## Wollongong Local Planning Panel Assessment Report | 5 December 2018

<b>WLPP No.</b>	Item 2
<b>DA No.</b>	DA-2018/819
<b>Proposal</b>	Landscaping works, retaining wall and fencing
<b>Property</b>	7 Spray Street, Thirroul
<b>Applicant</b>	Matthew Benson
<b>Responsible Team</b>	Development Assessment and Certification – Building Certification (CB)

### ASSESSMENT REPORT AND RECOMMENDATION

Figure 2: Proposed fencing

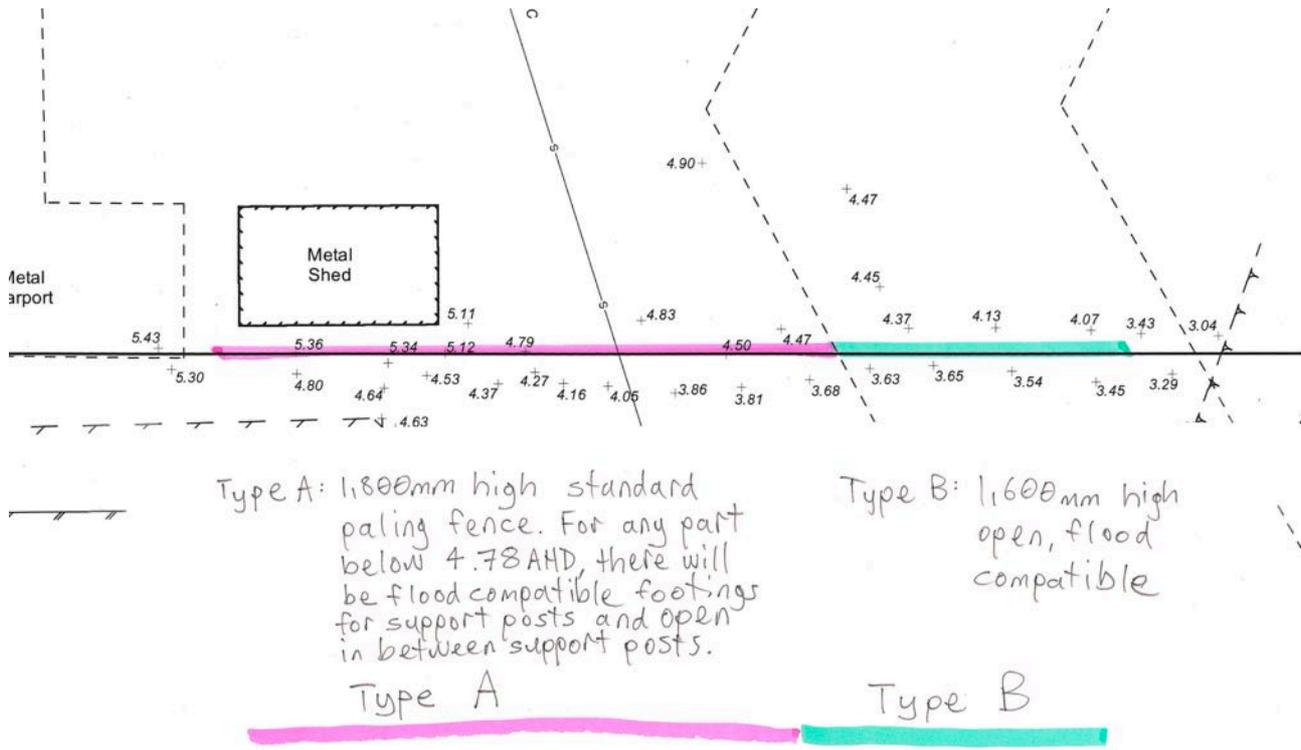
Despite that however, my client is accepting of part of the fence being limited to a height of 1600mm and being of a completely open-type. The part that would be of that type is indicated in Figure 2 below. For the part that is of standard paling type, there would be parts that are up to around 300mm below the 1 in 100 year flood level. For those parts, the support posts would have flood compatible materials below the flood level and the spaces in between the support posts below the 1 in 100 year flood level would be open.

A suitable condition of consent to reflect the foregoing, and to reflect Figure 2, would be:
